CITY PLAN COMMISSION**THURSDAY, FEBRUARY 6, 2025****FILE NUMBER:** S245-072**SENIOR PLANNER:** Hema Sharma**LOCATION:** St. Augustine Road, North of Lake June Road**DATE FILED:** January 8, 2025**ZONING:** PD 1117**PD LINK:** <https://dallascityhall.com/departments/city-attorney/Articles/PDF/Article%201117.pdf>**CITY COUNCIL DISTRICT:** 5**SIZE OF REQUEST:** 26.634-acres**APPLICANT/OWNER:** Jonathon Bazan, Dallas County

REQUEST: An application create a 90-lot single family subdivision with lots ranging in size from 3,570.95 square feet to 21,796.73 square feet and 7 common areas and to dedicate rights-of-ways from 26.634-acre tract of land on property located on St. Augustine Road, north of Lake June Road.

PRELIMINARY PLAT
LAKE JUNE VILLAS ADDITION
LOTS 1-9, BLOCK B/6715, LOTS 1-43, BLOCK
C/6715, LOTS 1-17, BLOCK D/6715, LOTS
1-21, BLOCK E/6715, COMMON AREAS "A-G",
SITUATED IN THE SOLOMON CARRIER SURVEY,
ABSTRACT NO. 260, CITY OF DALLAS, DALLAS
COUNTY, TEXAS.
26.634 ACRES
FILE NO. S245-072
PAGE 2 OF 2

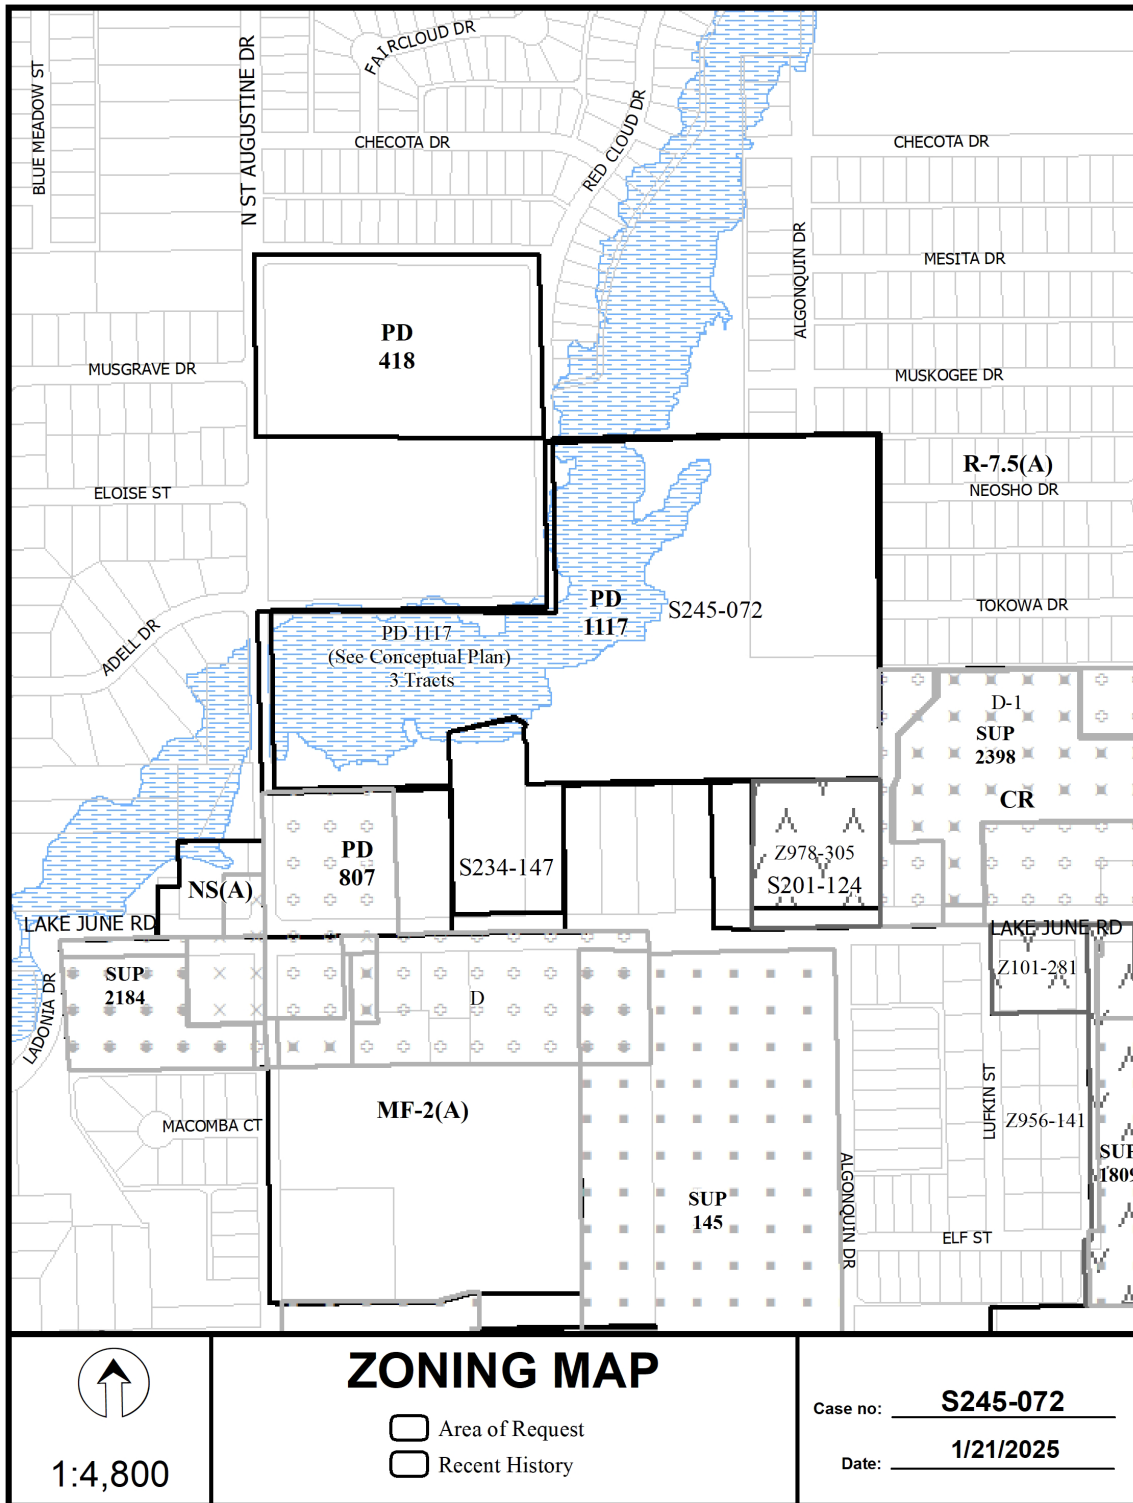
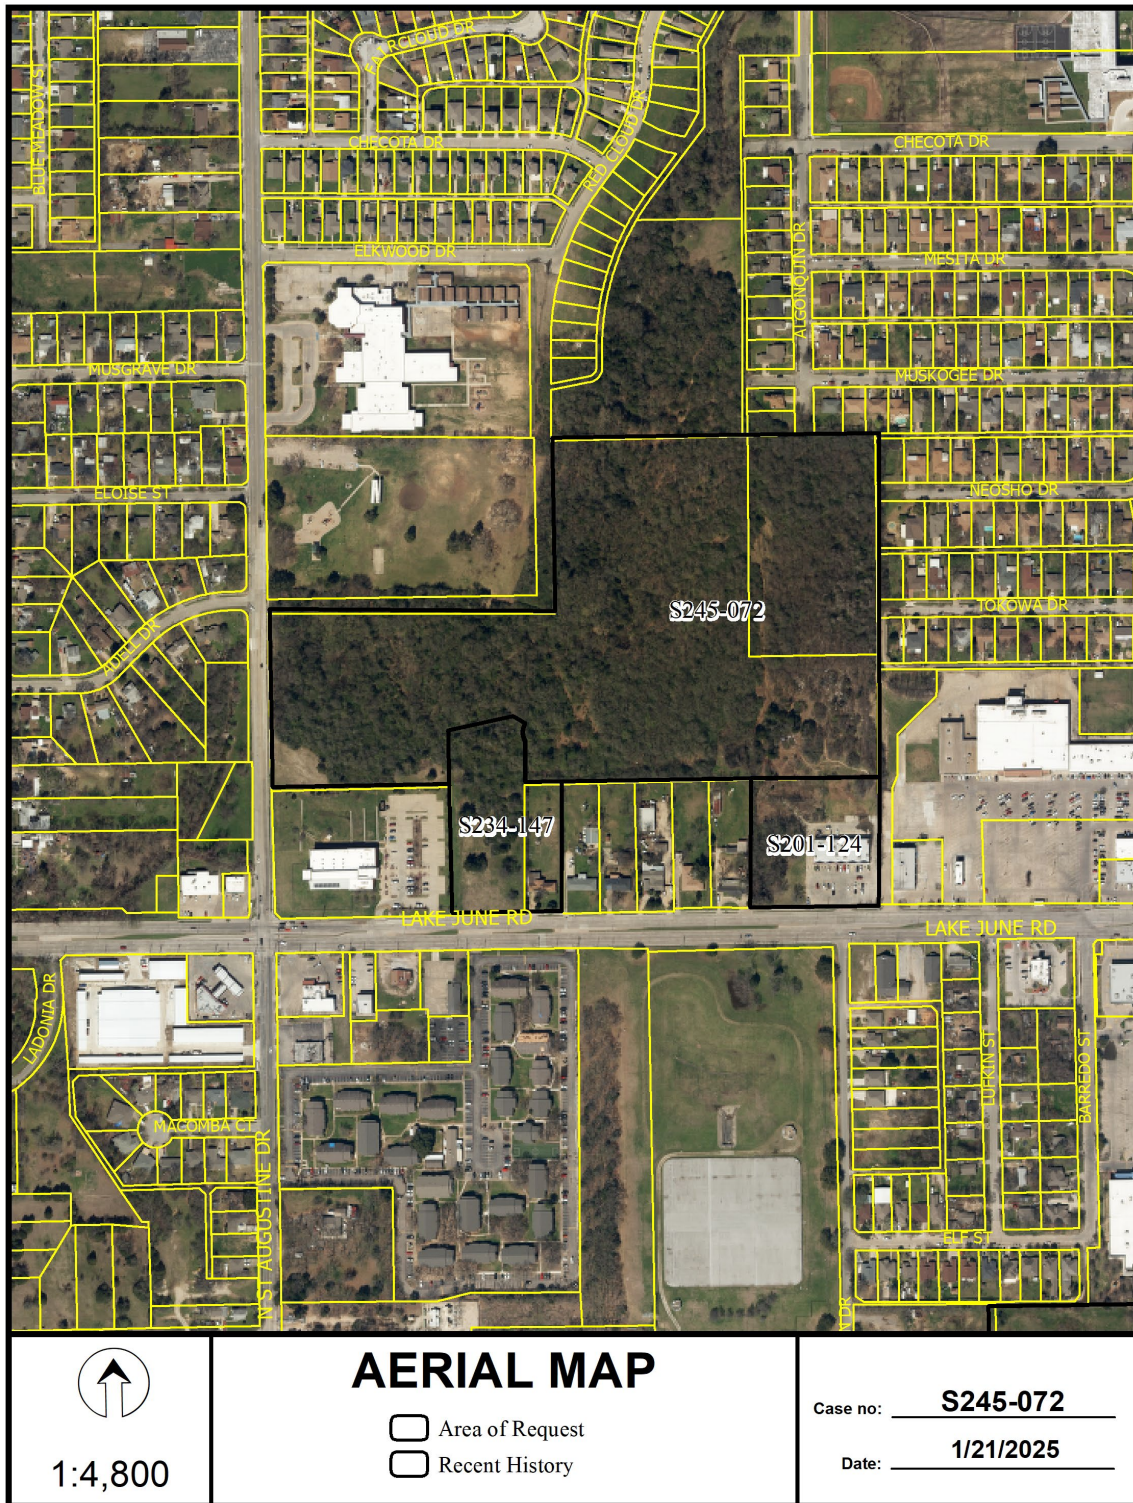
24. Prior to final plat, submit a completed final plat checklist and all supporting documents.
25. On the final plat, show how all adjoining right-of-way was created. Section 51A-8.403(a)(1)(A)(xxii).
26. On the final plat, show recording information on all existing easements within 150 feet of the property.
27. Prior to final plat, coordinate with the City Chief Arborist if proposed conservation easement needs to be done by separate instrument before plat is recorded or it can be done by plat.

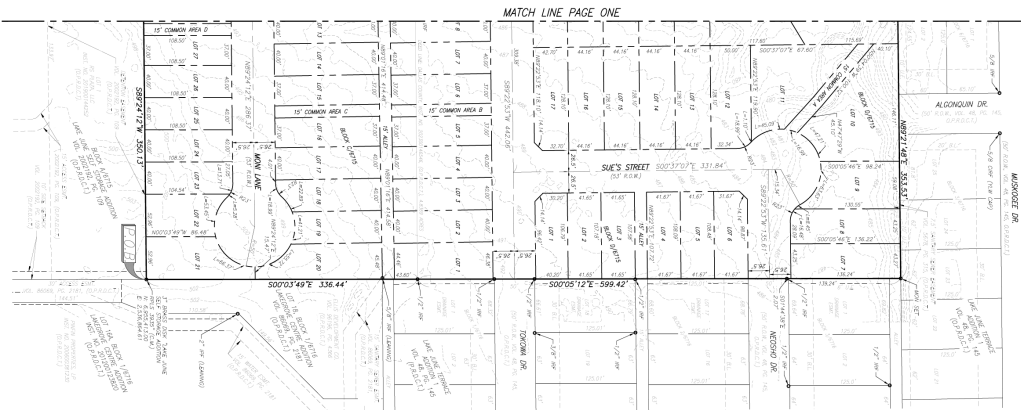
32. Prior to final plat, compliance with City's street lighting standards including illumination standards, material, installation, and activation per Street Design Manual.
33. Prior to the final plat, clarify the items indicated on the plat- 5 feet Wall Easement Plat pending, Water Easement Plat pending, Floodway Easement pending.
34. Prior to the final plat, please confirm if the Drainage Easement is being dedicated by this plat.
35. On the final plat, change "Tonkowa DR" to "Tokowa Drive". Section 51A-8.403(a)(1)(A)(xii).
36. On the final plat, change "Tokowa DR" to "Tokowa Drive". Section 51A-8.403(a)(1)(A)(xii).
37. Prior to final plat, please contact addressing team with proposed names of for proposed ROWs.
38. On the final plat, identify the property as Lots 1 thorough 41, Block B/6715; Lots 1 through 43, Block C/6715; Lots 1 through 6, Block D/6715 and Common Areas A through G.
